ADDENDUM NO. 1

Renovation to Exterior/Interior RC Building Warrensburg Readiness Center Warrensburg, Missouri PROJECT NO.: T2306-01

May 17, 2024

A-100 9 OF 53 SHEETS 12/29/2023

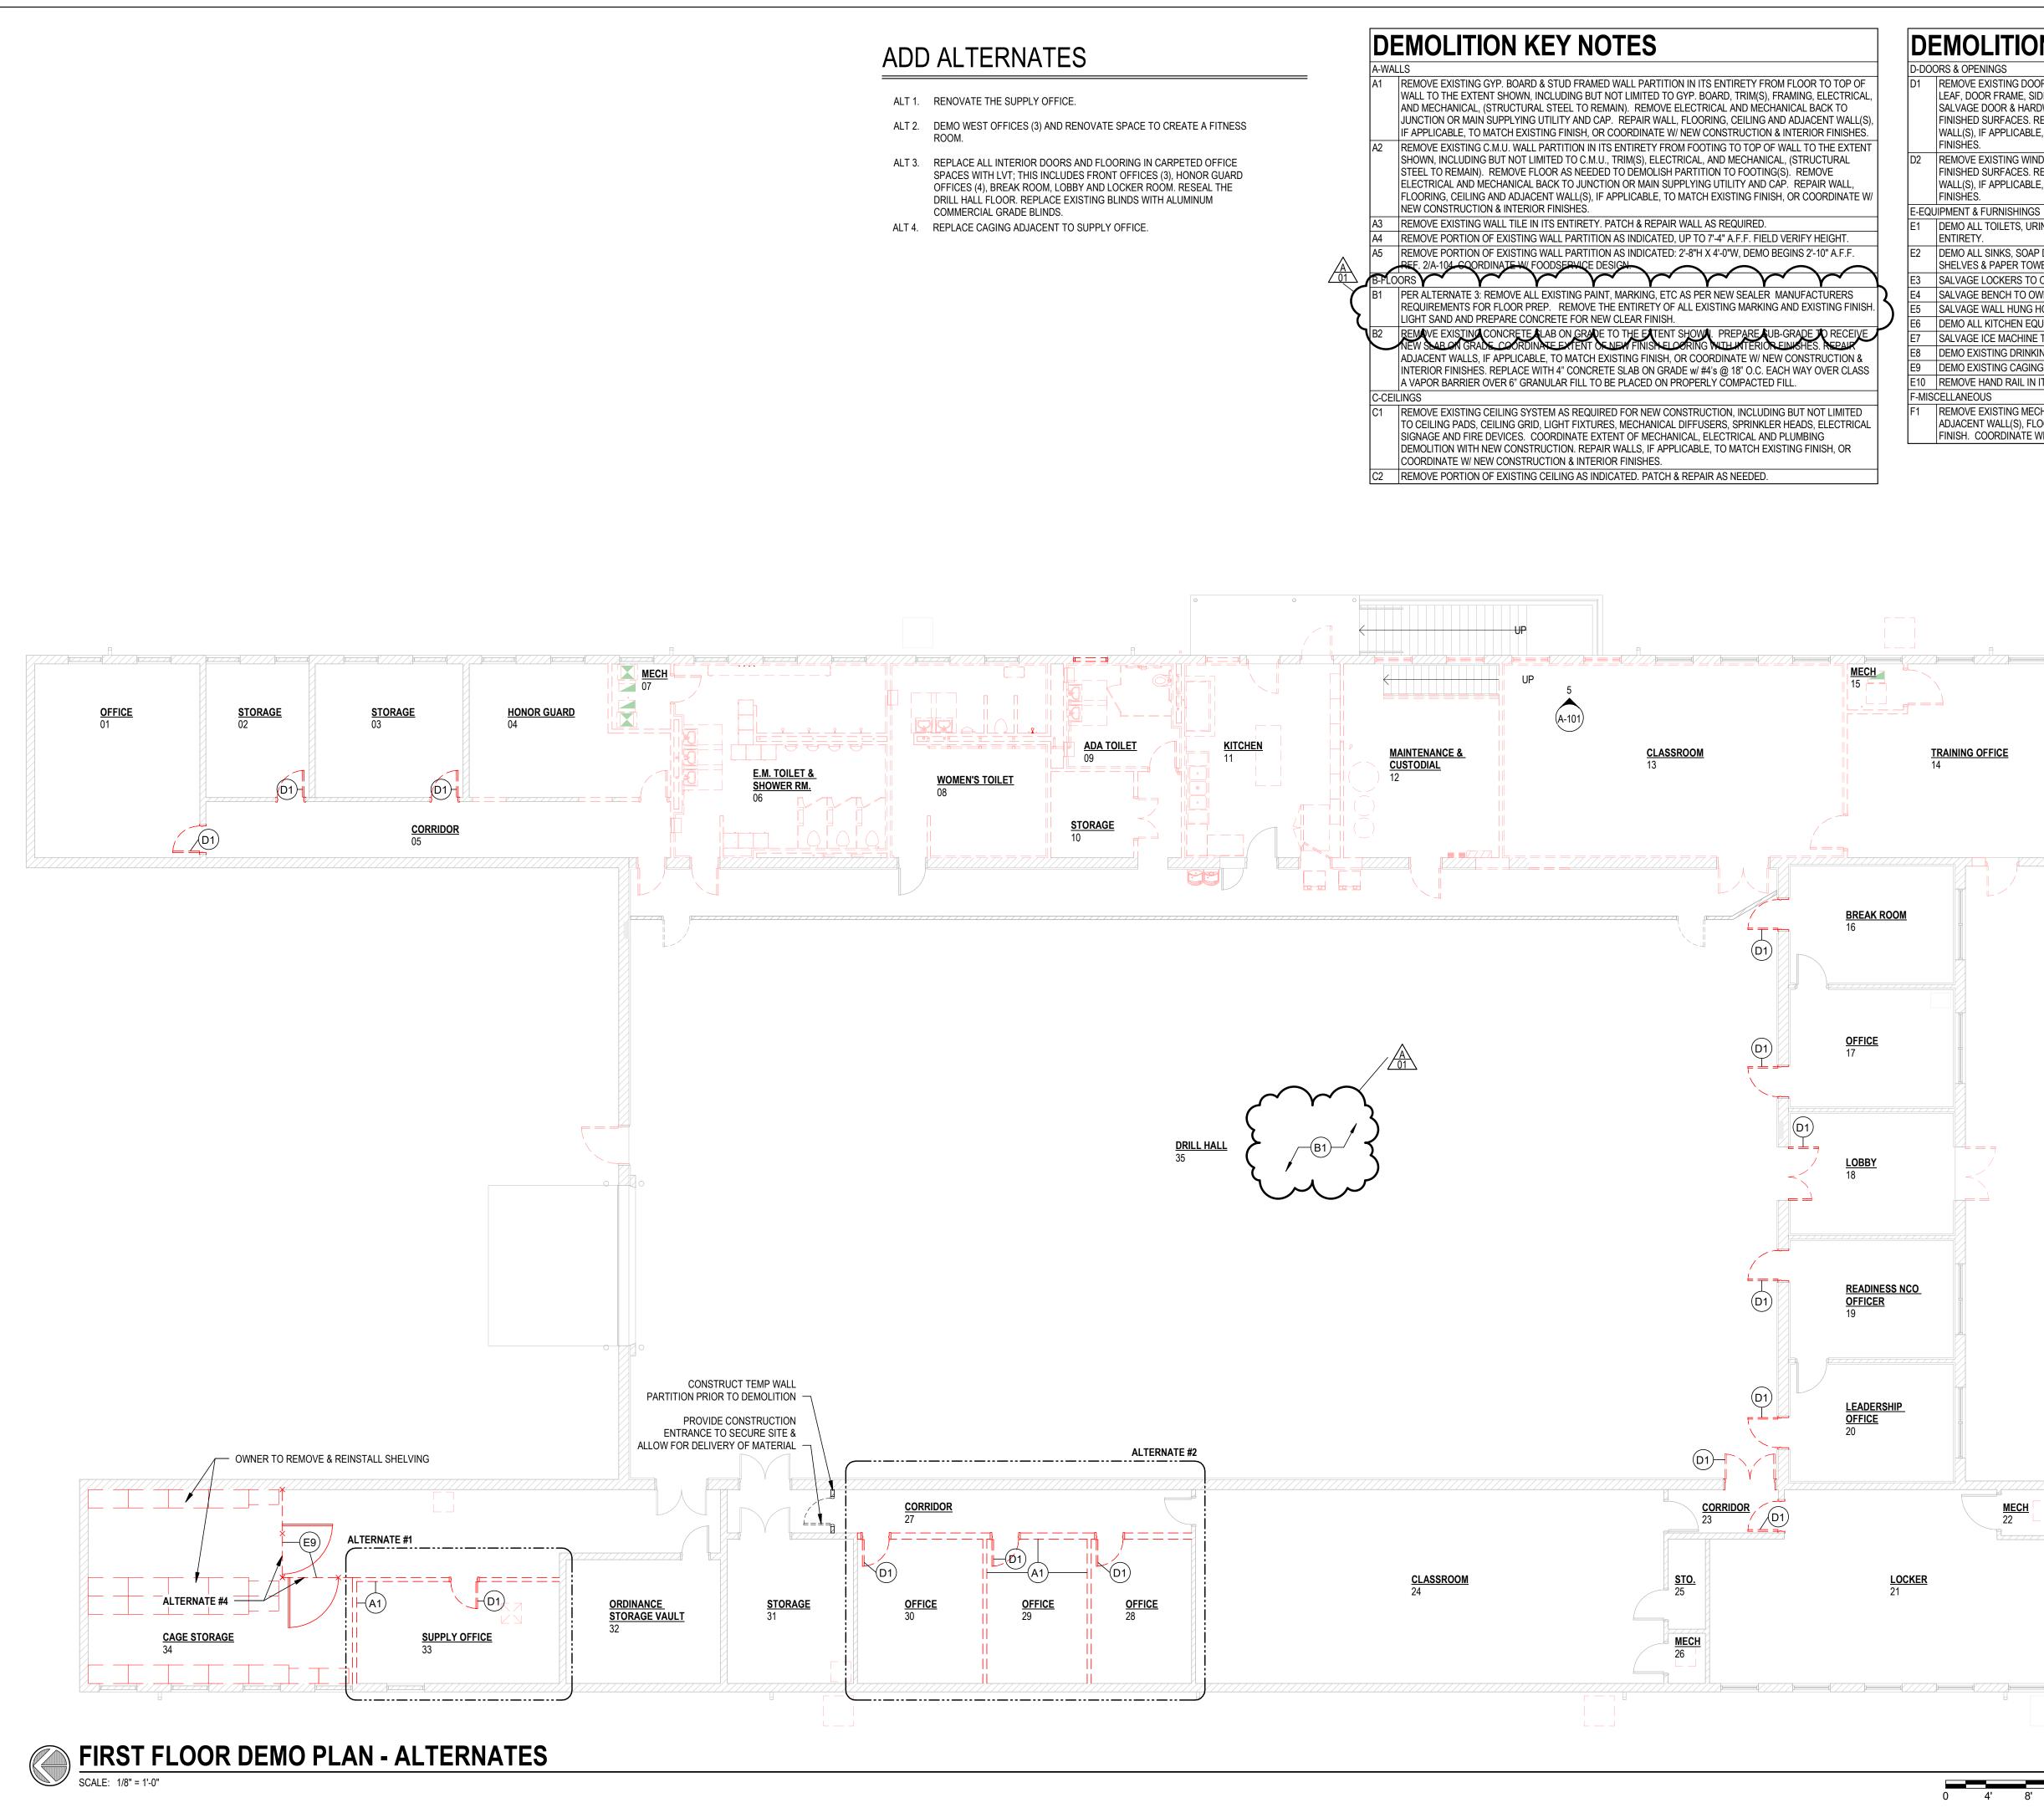
2. Sheet A-100 (attached)

- a. DELETE General Demolition Note 15: Asbestos abatement will be performed under separate contract. If asbestos is suspected or discovered during demolition, notify the architect.
- b. REVISE Note at temporary wall partition to include reference to wall type detail.
- c. ADD Note: RE: Sheet A100B for extents of slab demolition.

SHEET TITLE: Alternates Demolition Plan

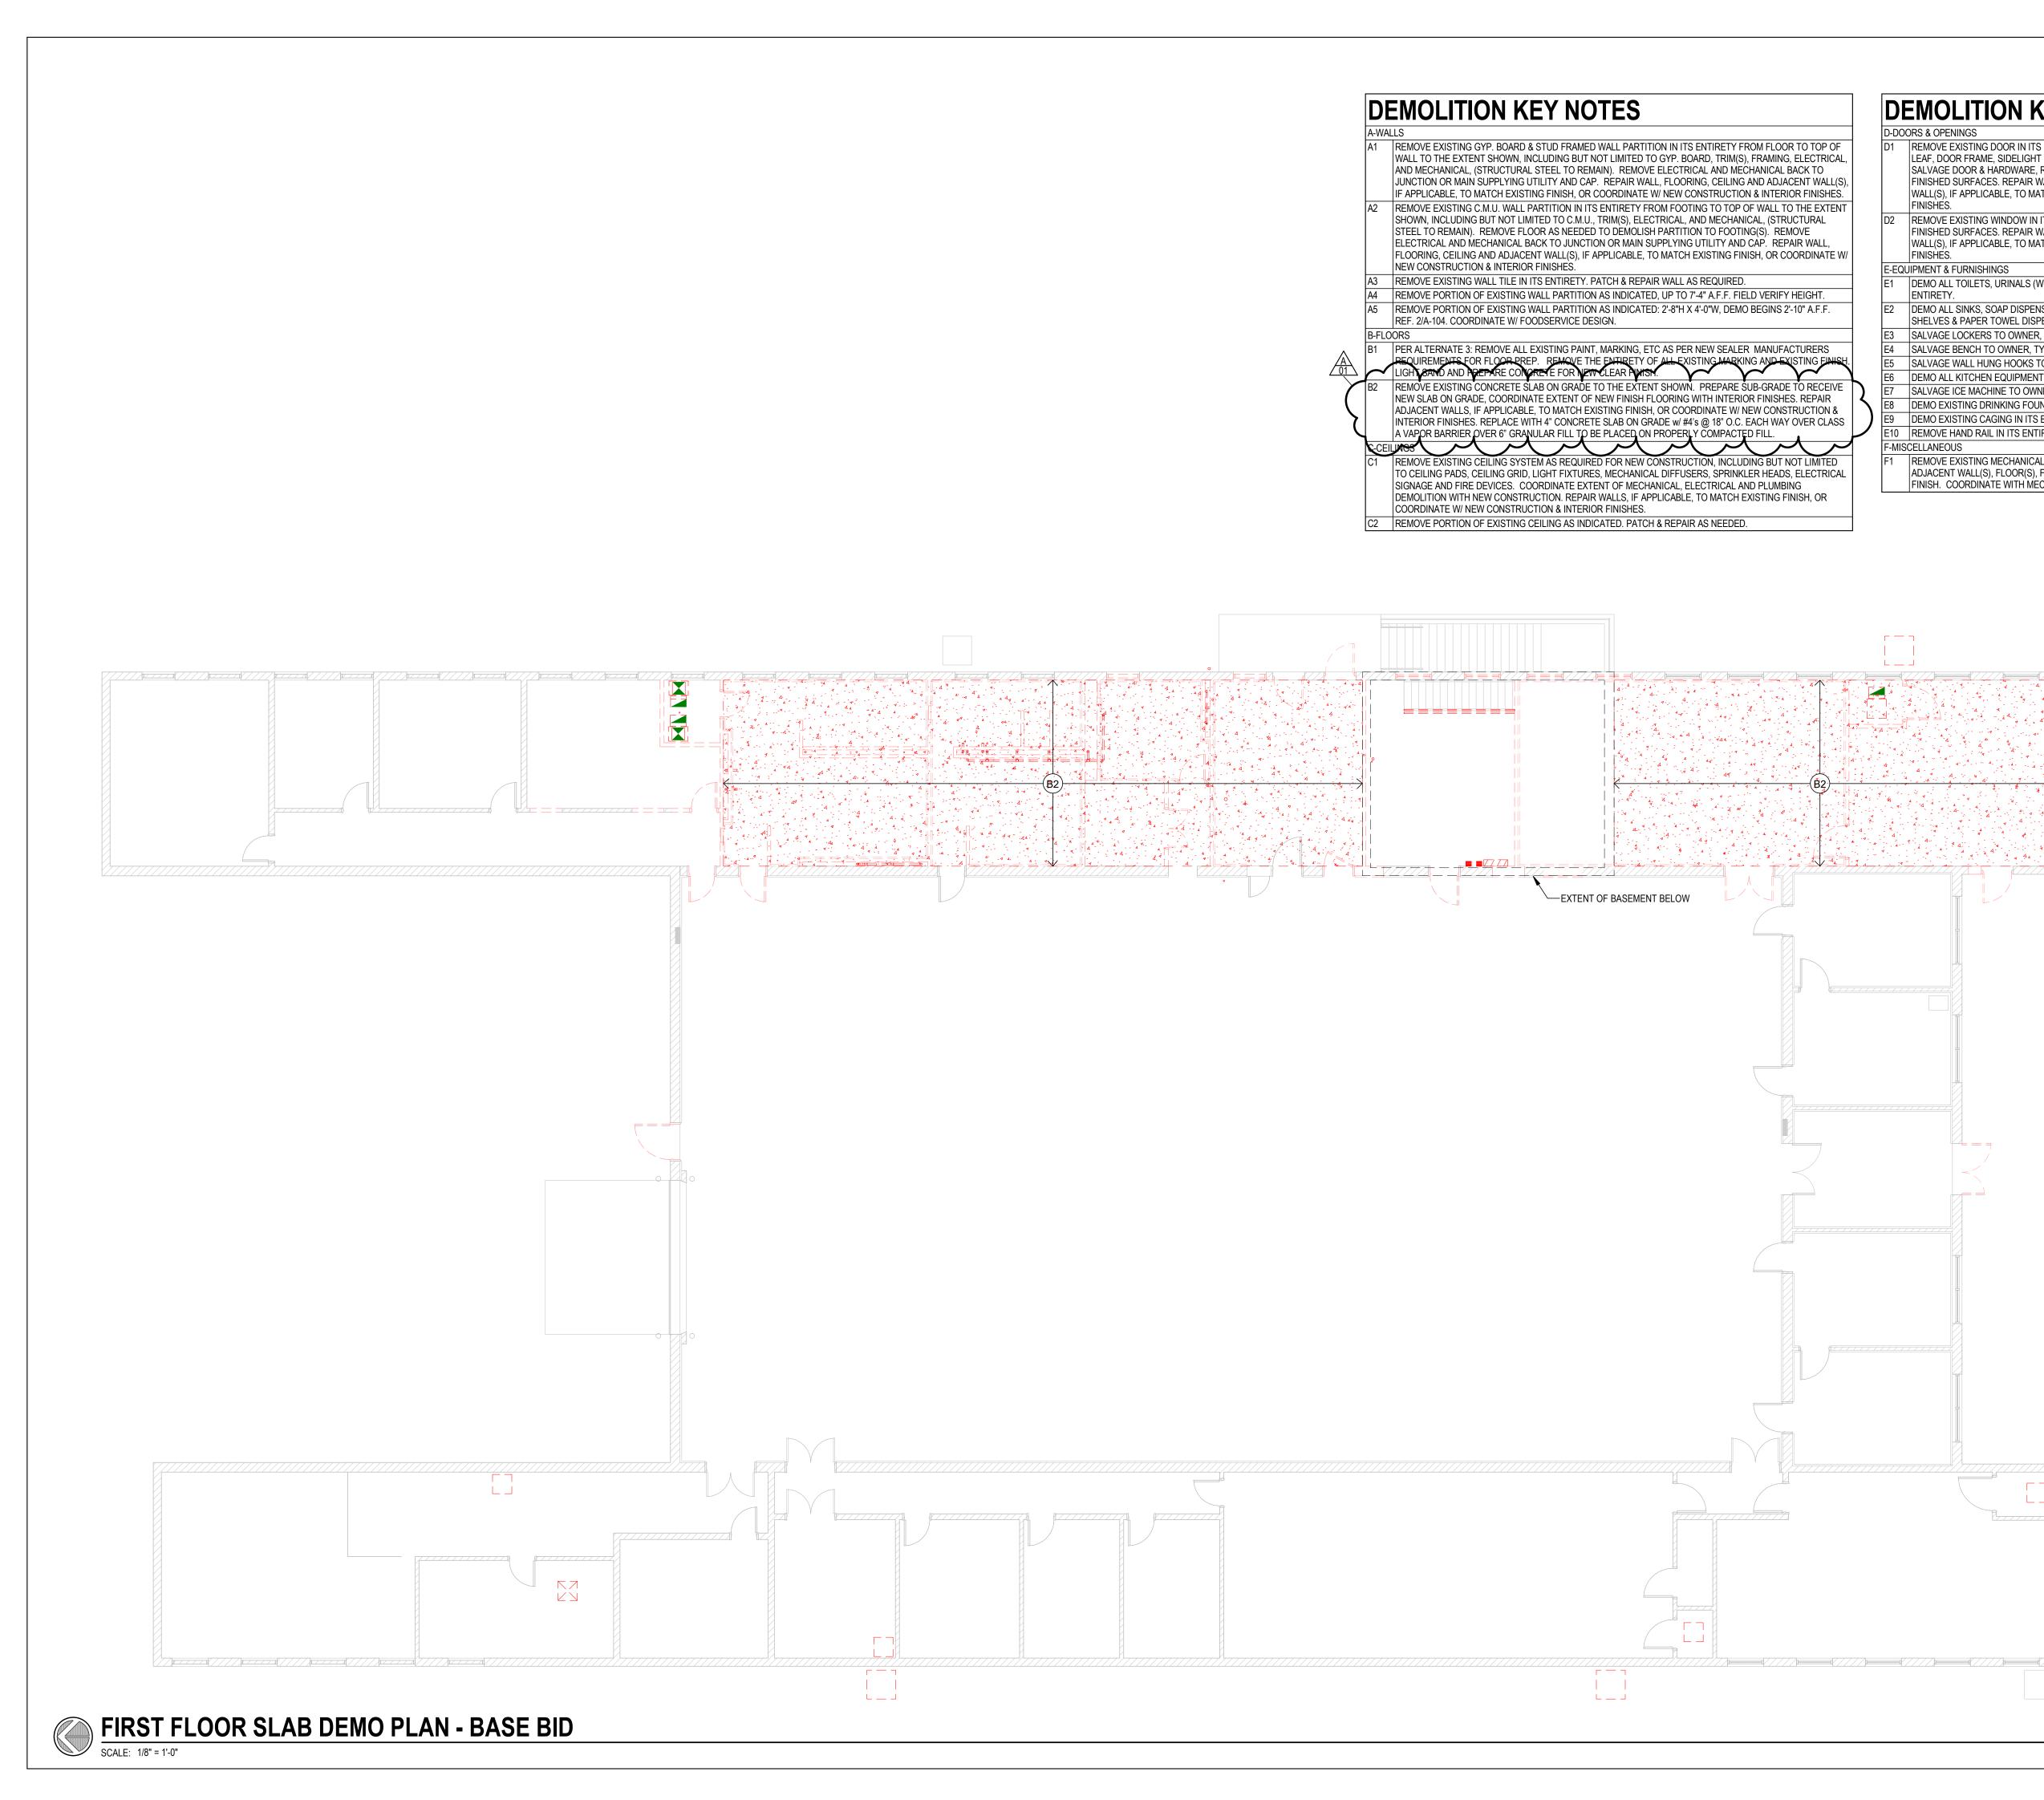
3. Sheet A-100A (attached)

a. ADD Demolition Key Note B1: Per Alternate 3: remove all existing paint, marking, etc as per new sealer manufacturers requirements for floor prep. Remove the entirety of all existing marking and existing finish. Light sand and prepare concrete for new clear finish.

SHEET TITLE: Base Bid Slab

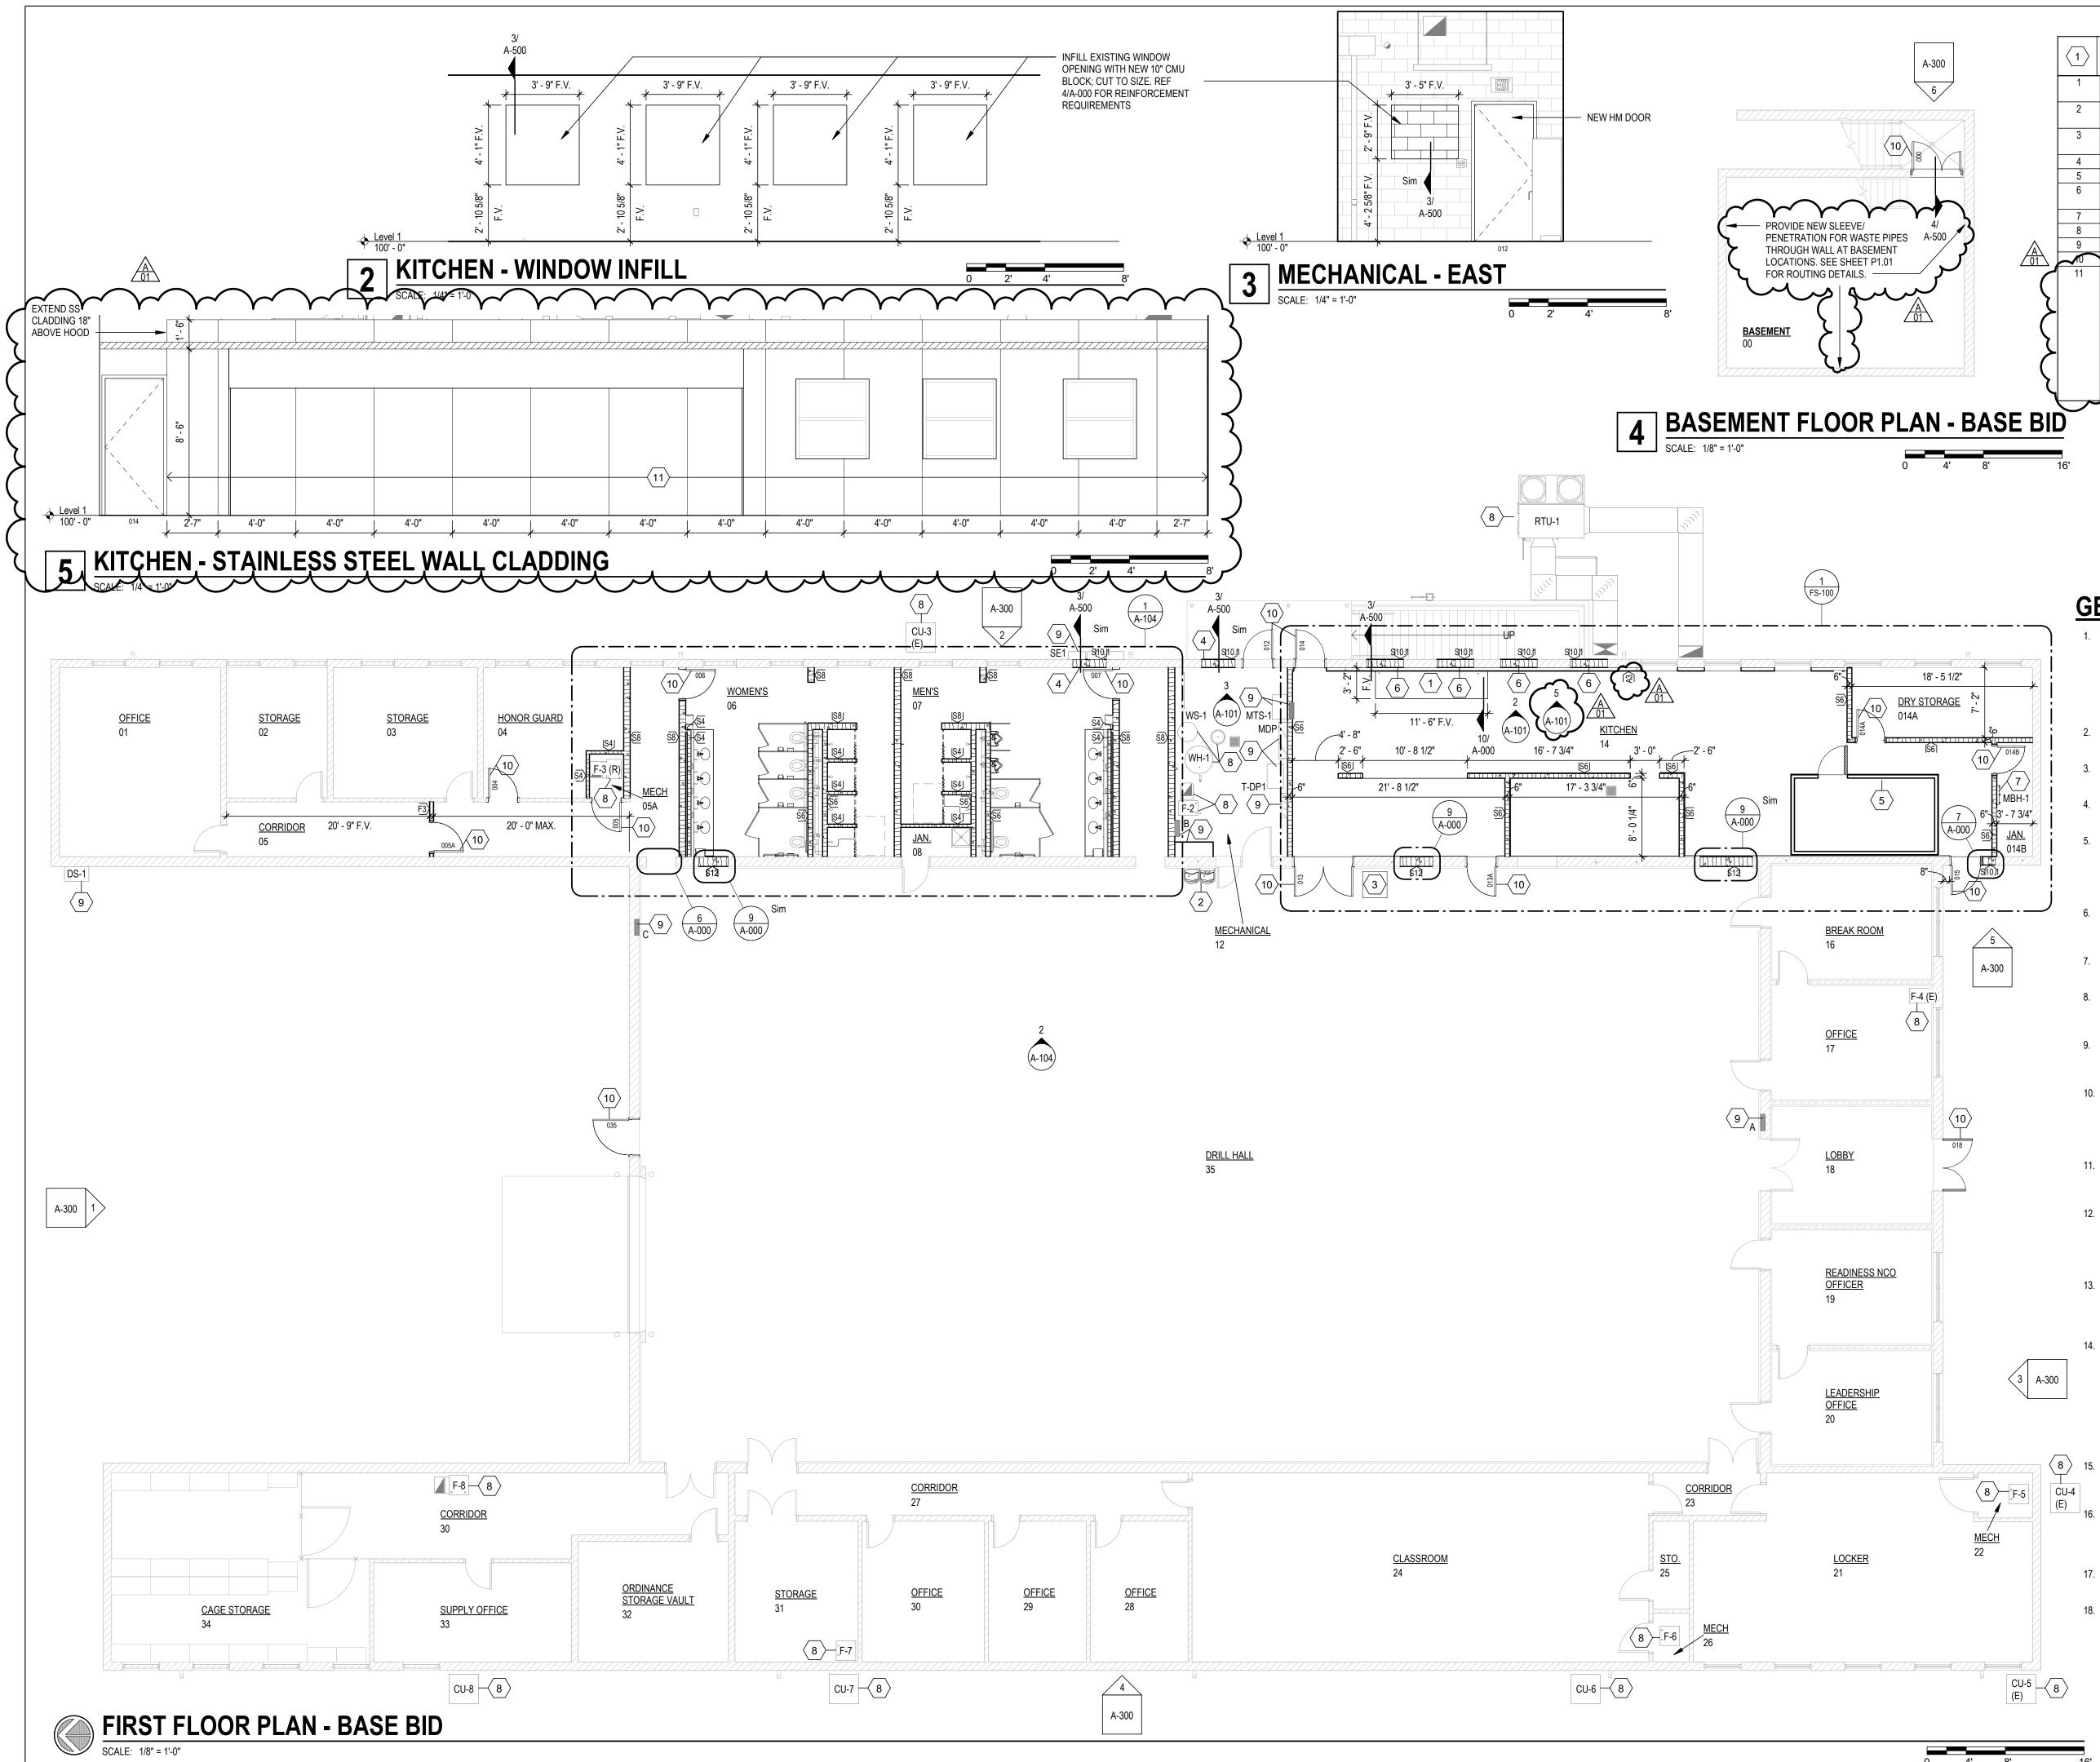
4. Sheet A-100B (attached)

- a. ADD Sheet A-100B Base Bid Slab Demolition Plan.
- b. ADD Demolition Key Note B2: Remove existing concrete slab on grade to the extent shown. Prepare sub-grade to receive new slab on grade, coordinate extent of new finish flooring with interior finishes. Repair adjacent walls, if applicable, to match existing finish, or coordinate with new construction & interior finishes. Replace with 4" concrete slab on grade w/ #4's @ 18" o.c. each way over class A vapor barrier over 6" granular fill to be placed on properly compacted fill.
